PLAN REVIEW SHEET

Petition: 2012-008

I. SUMMARY REMARKS:

STD. NO.	REV.
60.05A

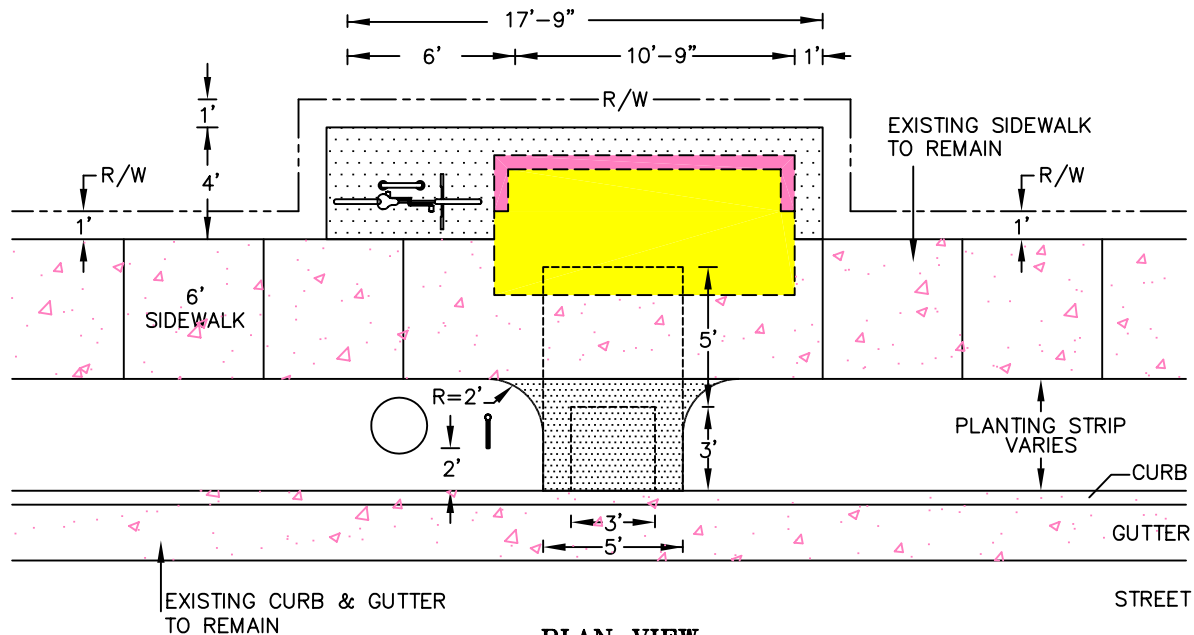
CATS requests that the Petitioner provide a concrete waiting pad as shown on the attached specification. Please contact Budd Early at CATS (704.432.2557) if there are any questions regarding this request. Thank you.
